# Planning Permit Officer Report

PA2302511: 81 Myers Street, GEELONG

Planning Permit Officer Report  
Development Approvals & Design

Figure 15: Ground floor and roof demolition plan

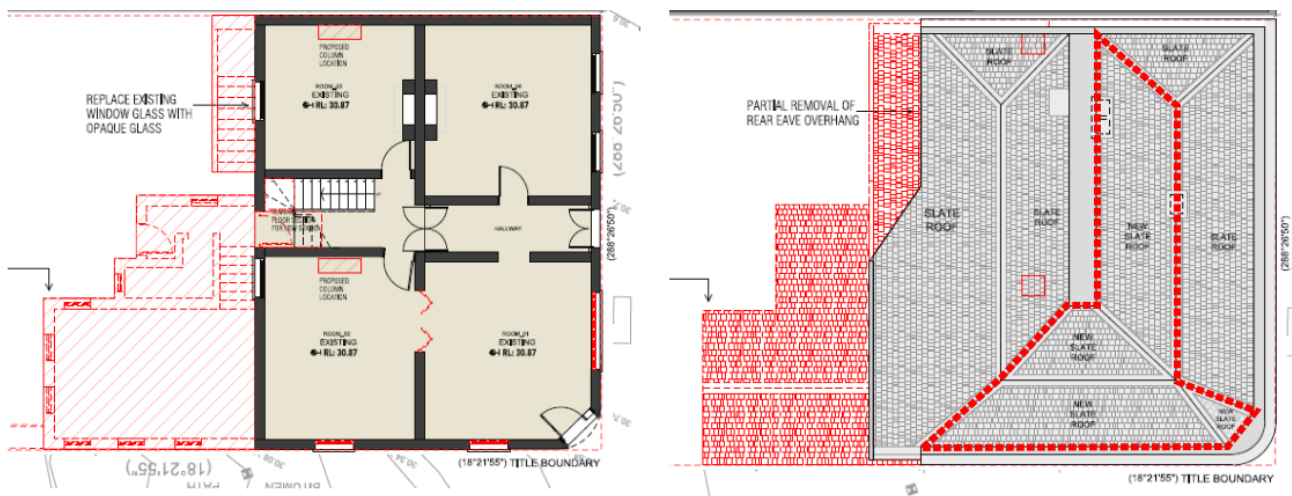
42. It is proposed to partially demolish the Star Hotel (heritage building), carve out new windows, open up internal areas and increase door openings (see Figures 14 and 15 below).

43. The submitted Heritage Impact Statement (HIS) prepared by Dr Aron Paul (M. ICOMOS) & Janice Yeung (Trethowan Architecture) dated 6 June 2023 indicates that the 1980s rear extension proposed to be demolished is acceptable as the structure demonstrates no architectural or historical contribution. The report suggests that the proposed demolition of remnant stucco patches and unsympathetic exterior paint finishes removes unsympathetic later additions and allows for a more even, new façade treatment. The authors consider the non-original windows, corner door, infill wall and the first floor verandah and its associated fabric to be unsympathetic modifications that detract from the cultural heritage significance of the place.

44. The report considers the removal of this later additions acceptable pursuant to clause 15.03-1L that encourages the removal of later unsympathetic modifications. The proposed works remove non-original elements that detract from the cultural heritage significance of the building and are acceptable. Their demolition would not detract from the cultural heritage significance of the place.

45. The report also considers the partial replacement of the steel roof sheeting to slate tiles as an acceptable heritage outcome as it rectifies the roof leakage issue and allows for the building's ongoing functioning into the future. It considers to be a sympathetic material that does not detract from the building's cultural heritage significance. The report also states that the reinstatement of stucco as a façade material is an acceptable heritage outcome.

Figure 18: Design details of the eastern facade

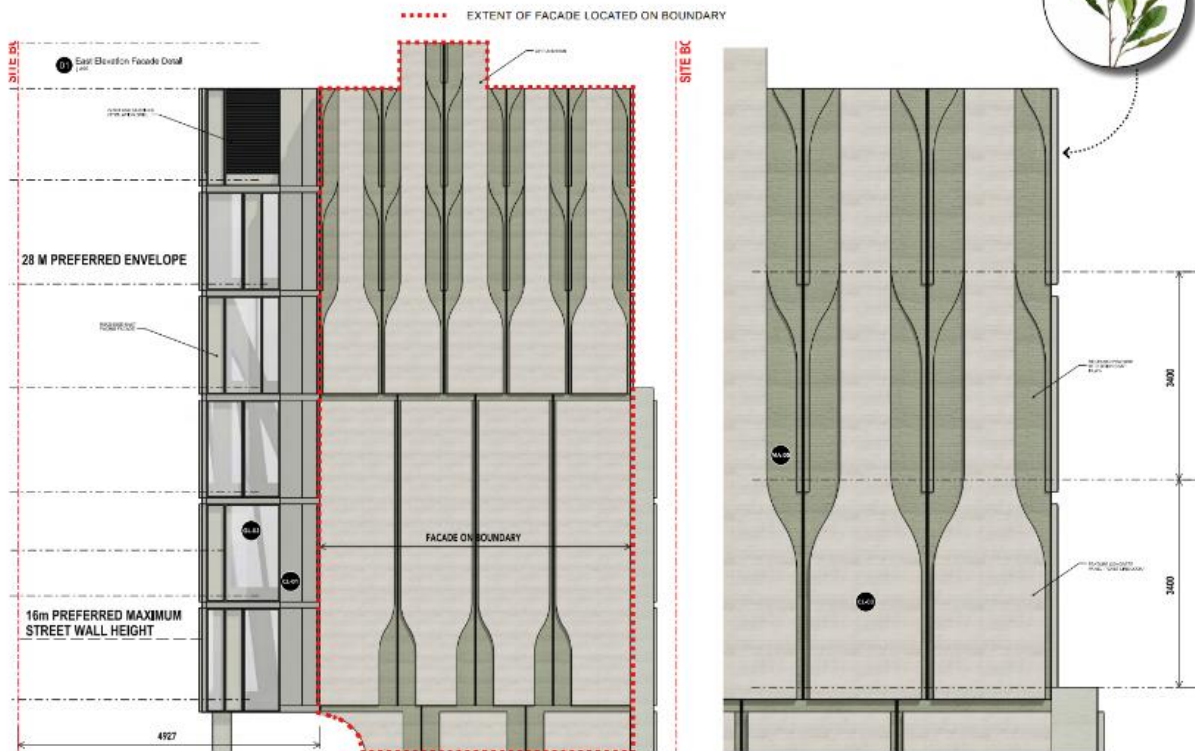
55. For the eastern elevation, there is an opportunity for further development to be constructed to the boundary. Along the boundary an expressed facade treatment is proposed, inspired by the leaf pattern of banksia trees and is faced in green snap bricks inlaid into the concrete panels. The concrete is precast with timber shuttering to give an effect of being formed with timber boards (see Figures 17 and 18).
